# SWITCHBOARD WP, SC, NT 1-7

## MODIFICATION OF OPERATORS TELEPHONE CIRCUIT FOR USE WITH TELE No.162 CB

N911  
5-5-55

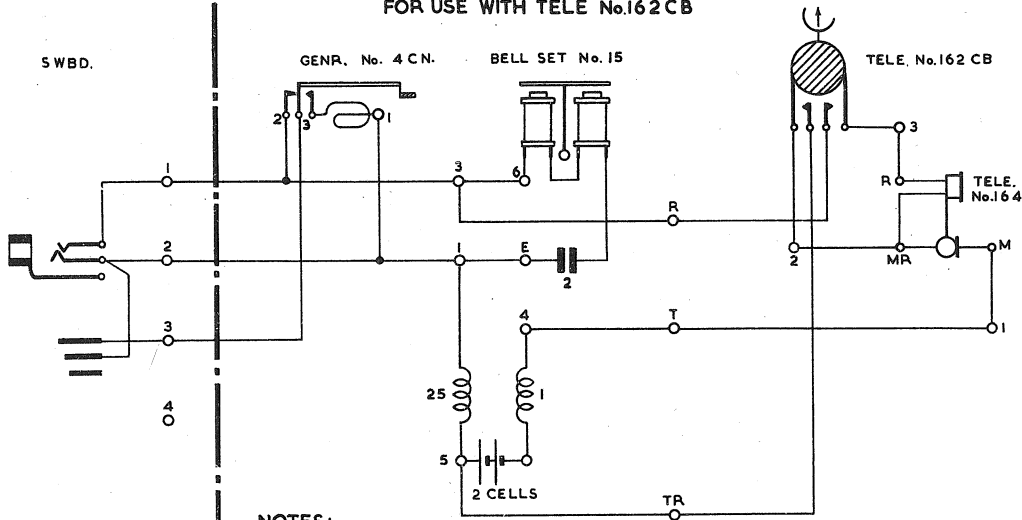
1. THE ANTI-SIDETONE COIL (TRANSFORMER No.35A) WHICH IS FITTED INSIDE THE STANDARD TELEPHONE No.162 IS NOT REQUIRED WHEN THE INSTRUMENT IS WORKING TO A LOCAL BATTERY SPEAKING SYSTEM. THE TRANSFORMERS No.35A SHOULD THEREFORE BE DISCONNECTED.
